ADDENDUM No. 2

Re: WCU Early Joyner Drive Infrastructure Package

JPA Project #: 20WCU777 SCO Project #: 22-24697-01B

C302B

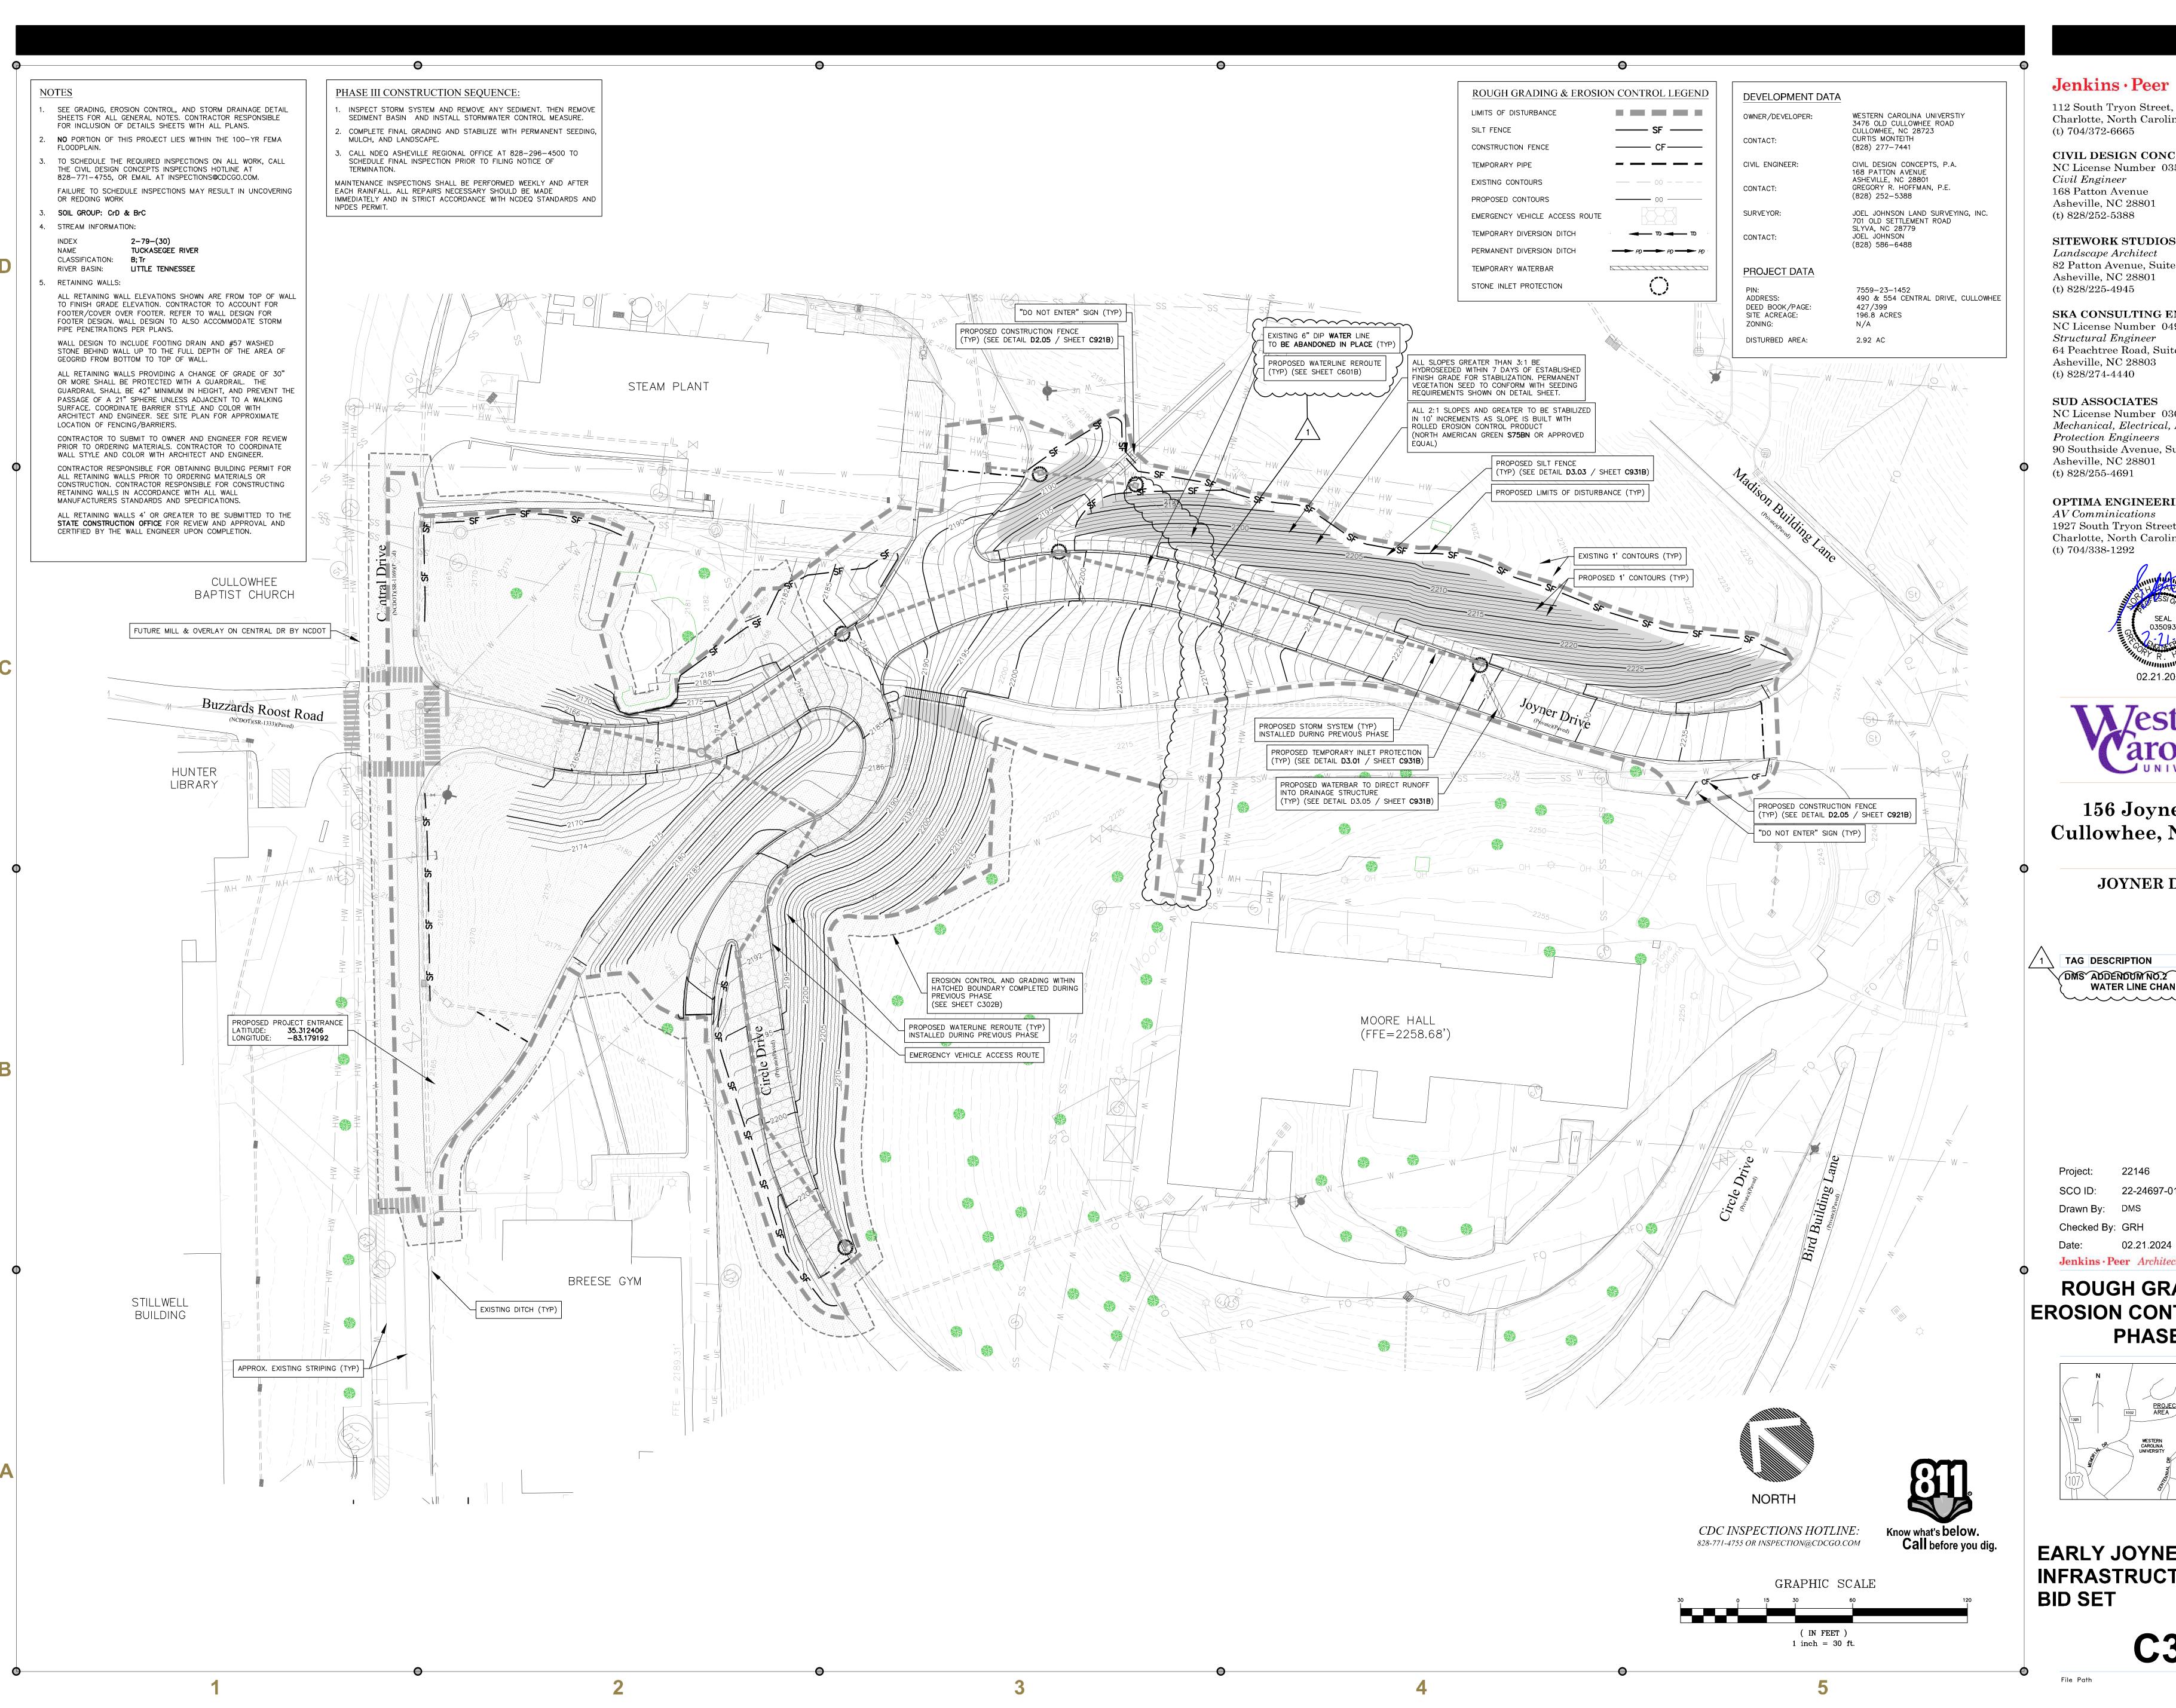
Item 3. C302B (Route of water relocation has been revised.)

C303B

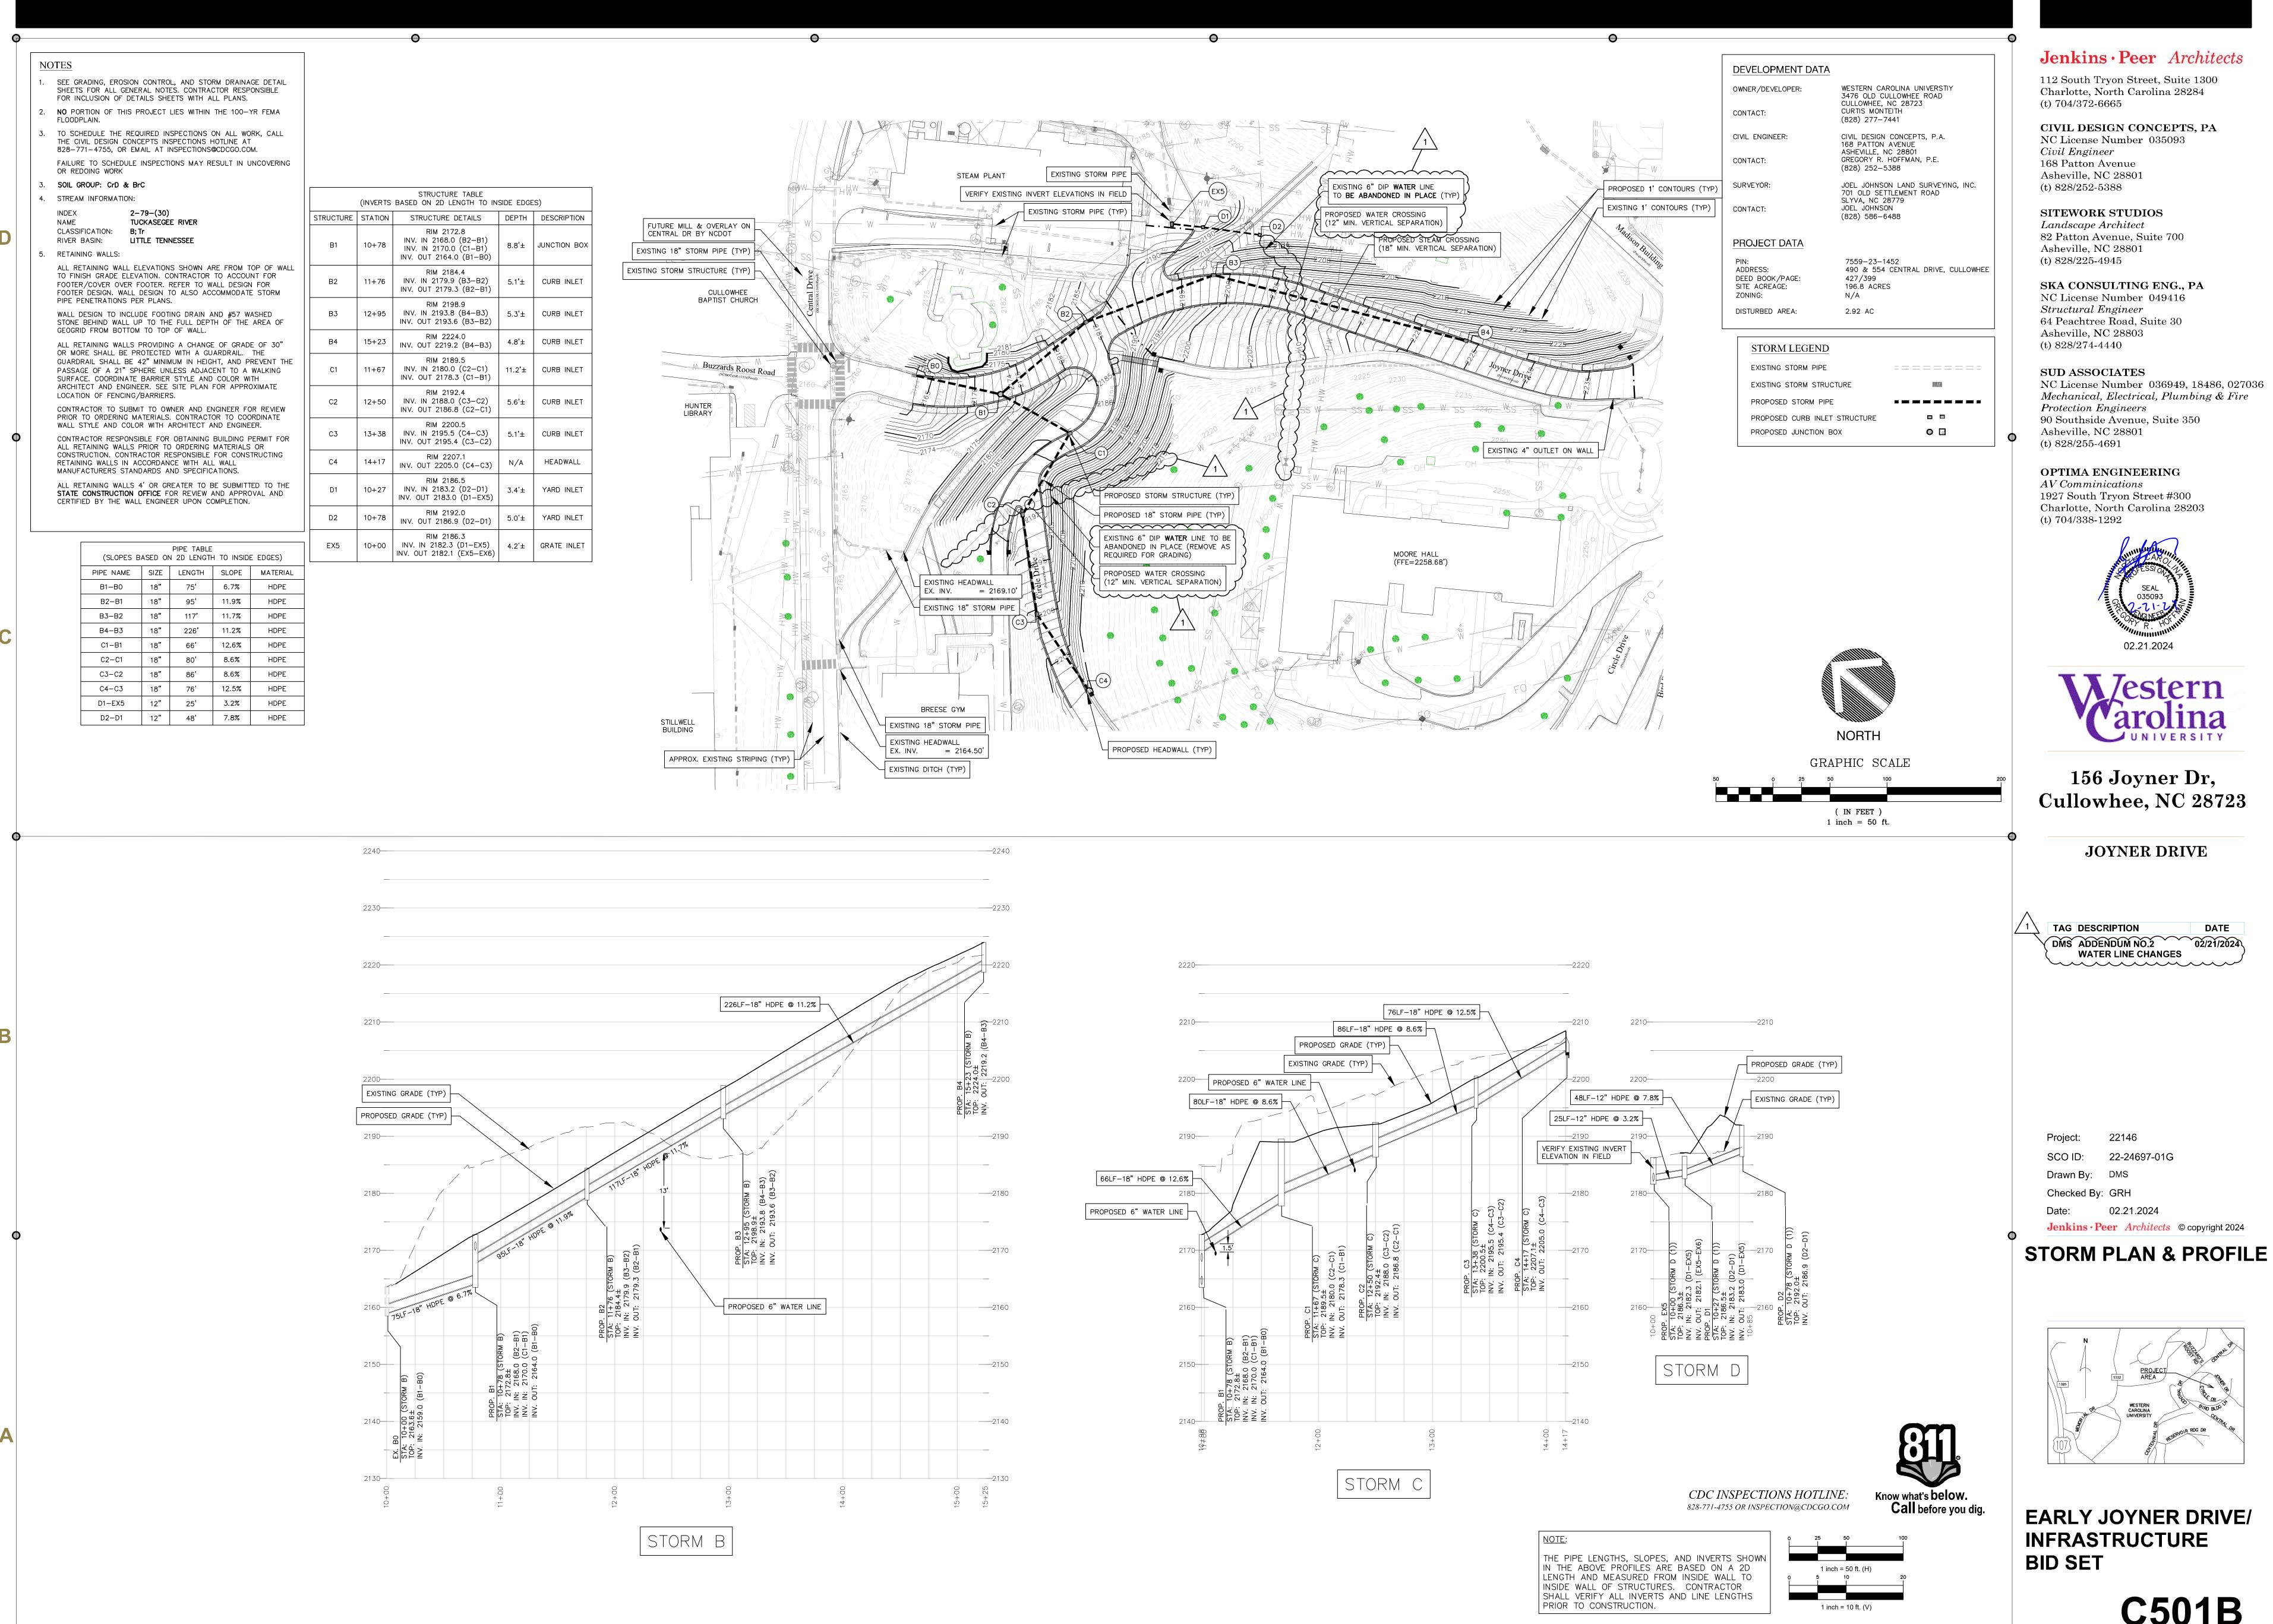
Item 4. C303B (Route of water relocation has been revised.)
